Applicant: Scott Neal: City of Edina
Consultant: Laura Clarens; Kimley Horn and Associates
Project: Aeon Edina
Location: 4100 West 76th Street: Edina
Rule(s): 4,5,11,12
Reviewer: BCO

General Background & Comments

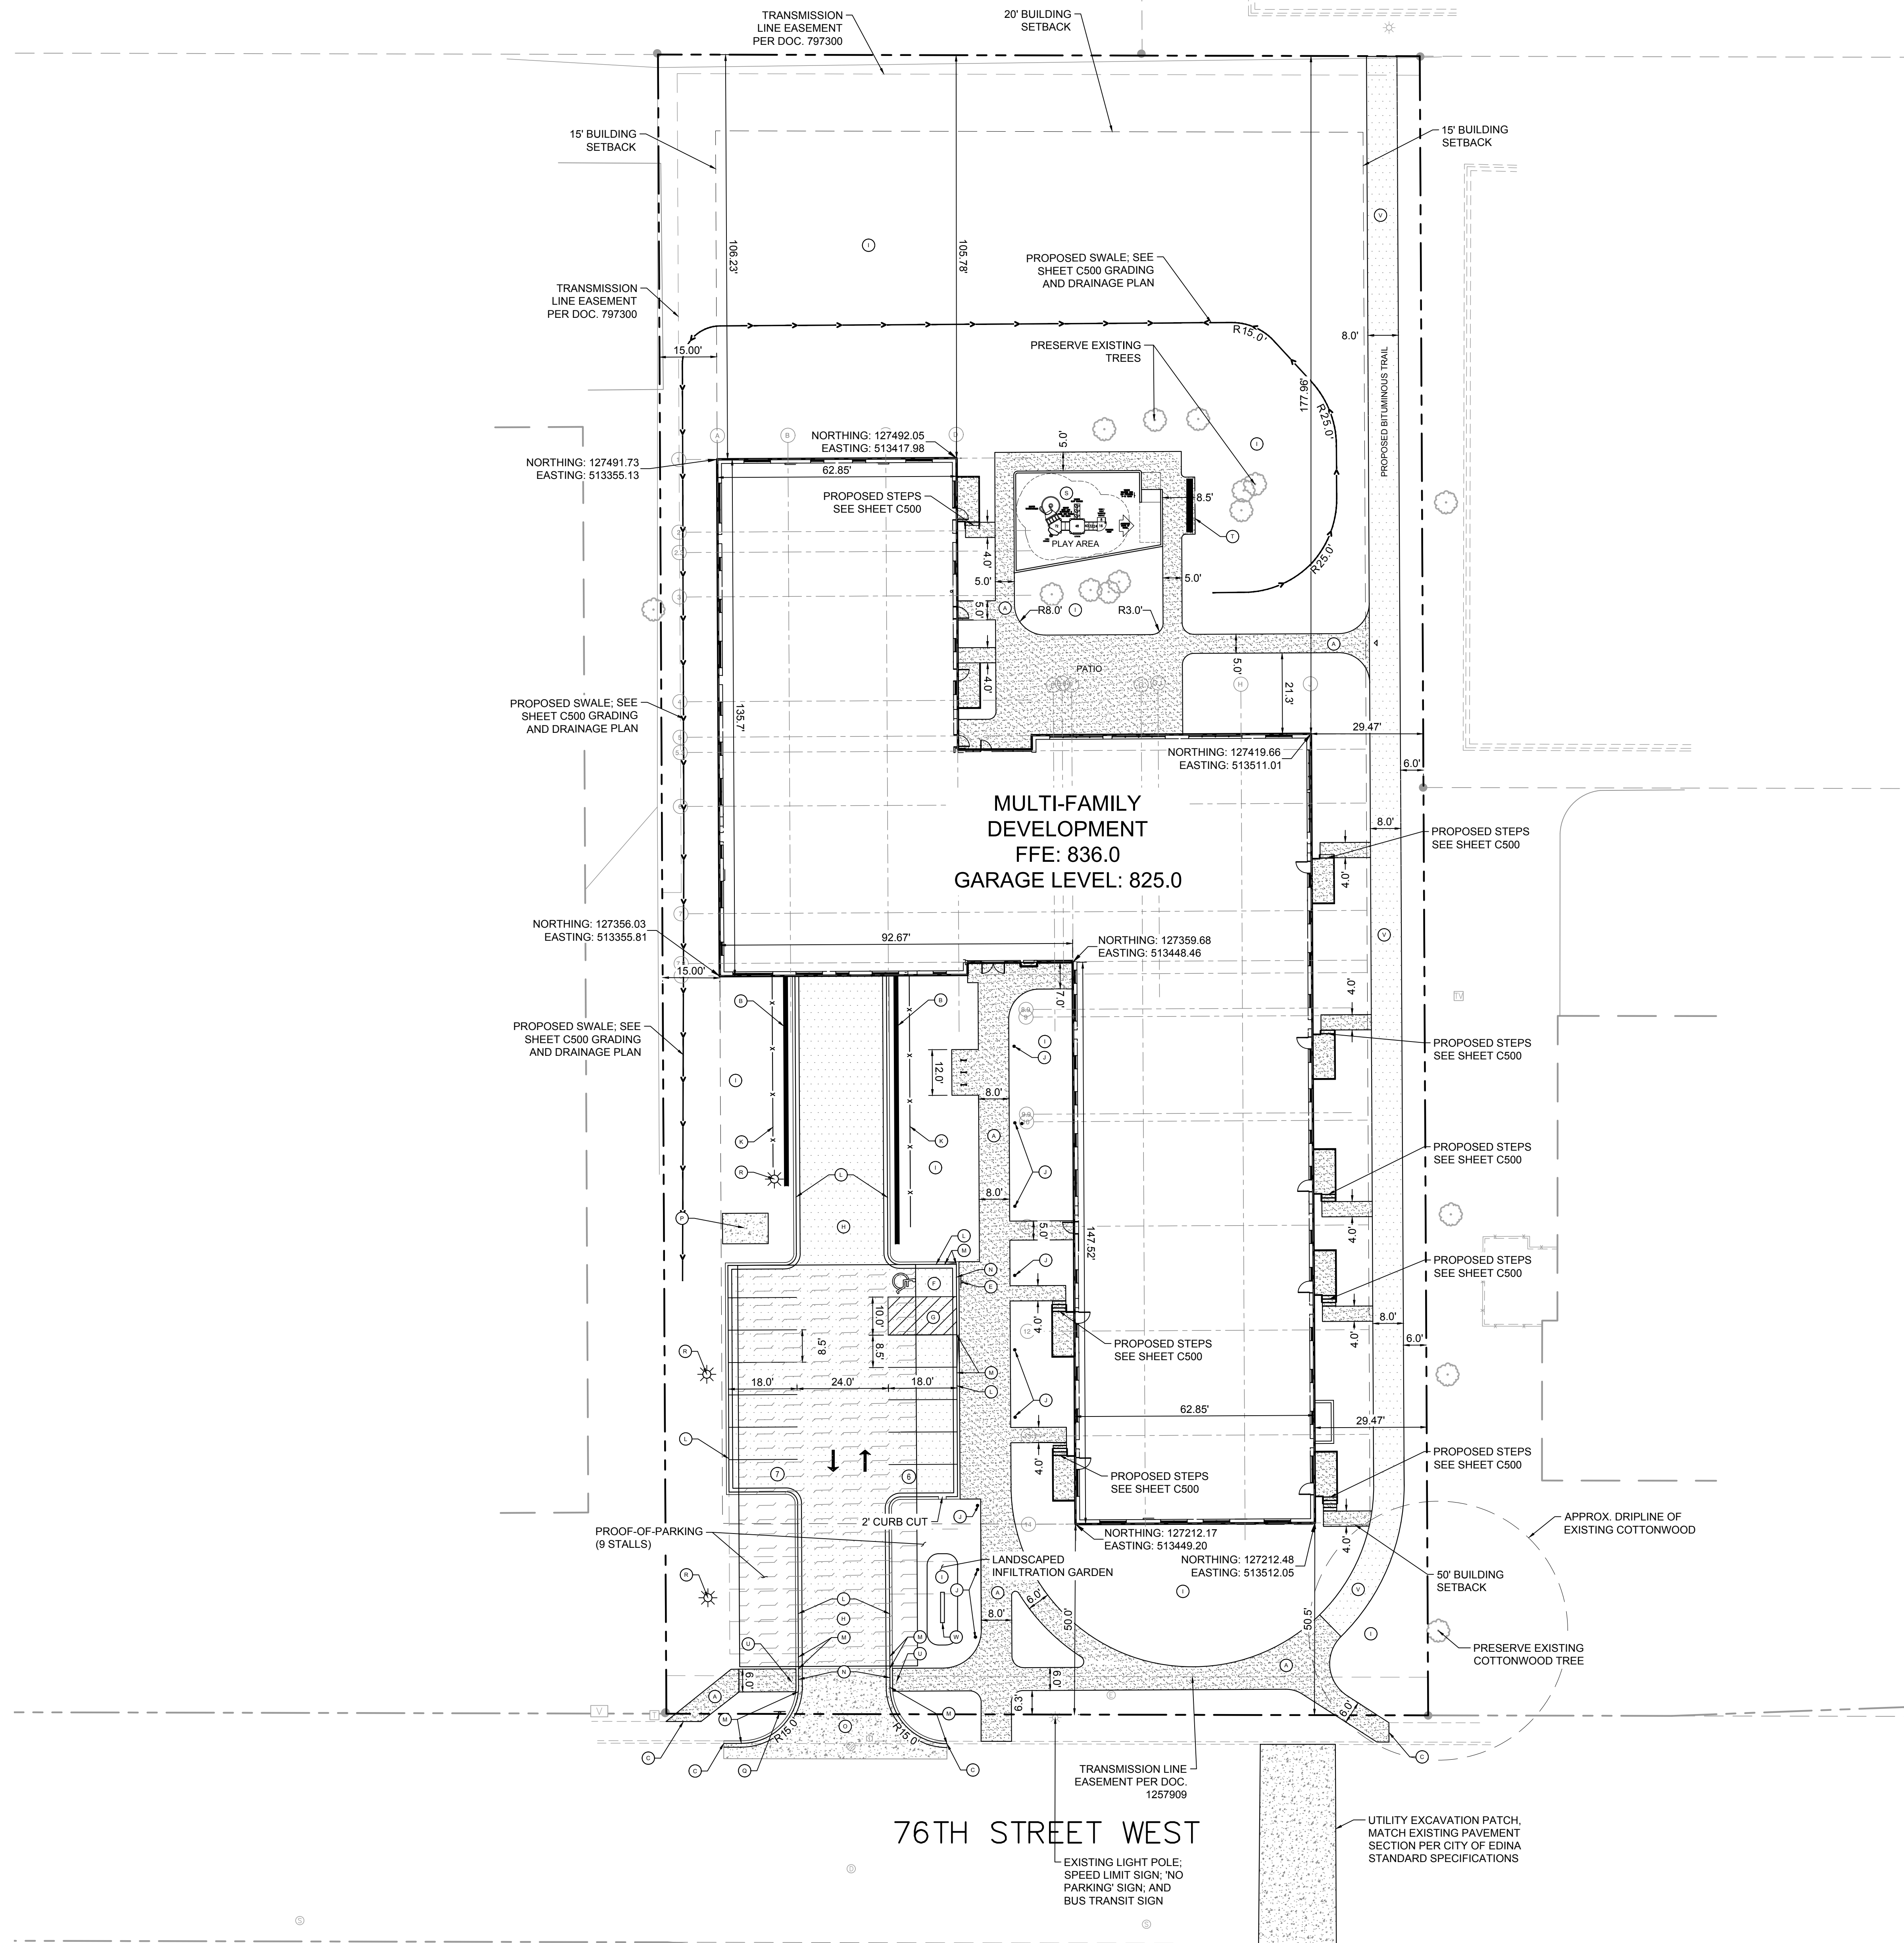
Storm water management is to be provided within an underground storm water management facility (UGSWMF) that will provide volume retention and water quality management. Rate control is provided by the proposed reduction in the on-site impervious area and further attenuated by the UGSWMF.

There is one discharge point from the project area. Rule 4.3.1b is met.

An infiltration volume of 3,674 cubic feet is required from the proposed 40,075 square feet of impervious area. The soil borings show the underlying soil in the location and depth of the proposed UGSWMF as a poorly graded sand (SP) having an infiltration rate of 0.8 inches/hour using the Minnesota Storm Water Manual. A volume of 10,148 cubic feet is proposed to be provided (3,674 cubic feet required) with an area of 4,846 square feet (1,148 square feet required) at an inundation depth of 3.2 feet within the UGSWMF. A minimum inundation area of 1,148 square feet at the 3.2 foot depth is required for the retention volume to be drawn down within 48 hours, Rule 4.3.1a (ii). Rule 4.3.1a is met.

In accordance with section 4.3.3 of the District rules, all structures riparian to inundation areas constructed or natural storm water management facilities must be located and elevations must be set according to Appendix 4A, "Low-Floor Elevation Assessment" of the District Rules. Referring to Plot 6 of Appendix 4A, with a horizontal distance of 42 feet between the proposed structure and the UGSWMF, the minimum permissible depth to groundwater is 0.27 feet. A separation of 5 feet (0.27 feet) will be provided between the proposed underground garage floor elevation (825 M.S.L.) and groundwater elevation (820 M.S.L.).

Rule 4.3.3 also states the elevation of a new and/or reconstructed building must be constructed such that no opening where surface water can enter the structure is less than two feet above the 100-year high water elevation of an adjacent facility or waterbody. The high point in the driveway to the underground parking from the surface parking lot is shown to be established at a minimum elevation of 833 M.S.L. providing a separation of 4.8 feet complying with the requirement of Rule 4.3.3.

In accordance with Rule 4.3.1a (i), the pre-treatment of runoff prior to reaching the UGSWMF will be provided by sump manholes constructed upstream of the two discharge point to the underground system.

Rule 4.5.4d (i), requires a minimum separation of 3 feet between the bottom of an infiltration facility, practice or system and groundwater. From the NTI geotechnical report, groundwater was encountered in boring SB-2 at a depth of 20 feet, elevation 820 M.S.L. The bottom of the UGSWMF is shown to be 824 M.S.L. providing a separation of 4 feet complying with Rule 4.5.4d (i).

Approval, contingent upon:

1. General Conditions
2. Financial Assurance in the amount of \$37,700 - \$32,700 for storm water management, erosion control and site restoration and \$5,000 for compliance with the chloride management requirements.
3. Submission of documentation that a drainage easement over the storm water-management facility has been submitted to Edina (4.5.4i), if such easement is required by the city, and a receipt showing recordation of a maintenance declaration for the on-site storm water management facility. A draft of the declaration must be approved by the District prior to recordation.

1. Per Rule 4.5.6, an as-built drawing of the storm water facility conforming to the design specifications, including a stage volume relationship in tabular form for the UGSWMF, as approved by the District must be submitted.
